Technical product information

Topic	Door profile incorrect
Market area	Bentley: worldwide (2WBE),Hongkong-Macau (5HK)
Brand	Bentley
Transaction No.	2046061/1
Level	EH
Status	Approval
Release date

Door profile incorrect

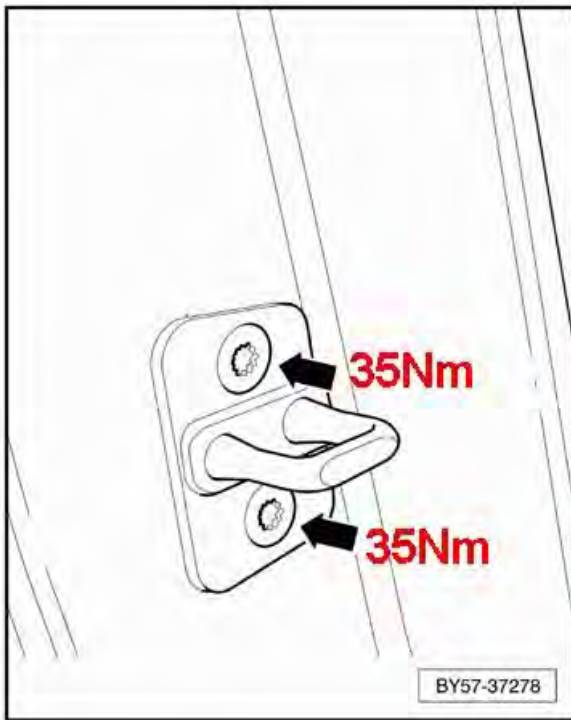
Door profile poor / Door not closing fully

Door profile can be compromised by door latch striker plate moving. Door latch striker plate can move when the fastener torque relaxes

Fastener torque increased to 35Nm on door latch striker plate fasteners

In the event of a door not fully closing and or poor door to body profile then check the remaining torque on the door latch striker plate fasteners. If the torque is less than 20Nm fit new fasteners, reset the door profile and then torque new fasteners to 35Nm.

If only one door is reported as affected and this TPI is subsequently applied then also replace the door latch striker fasteners on the opposite, unaffected, door and torque to 35Nm

Note: The door striker fasteners are single use always fit new fasteners when this TPI is applied
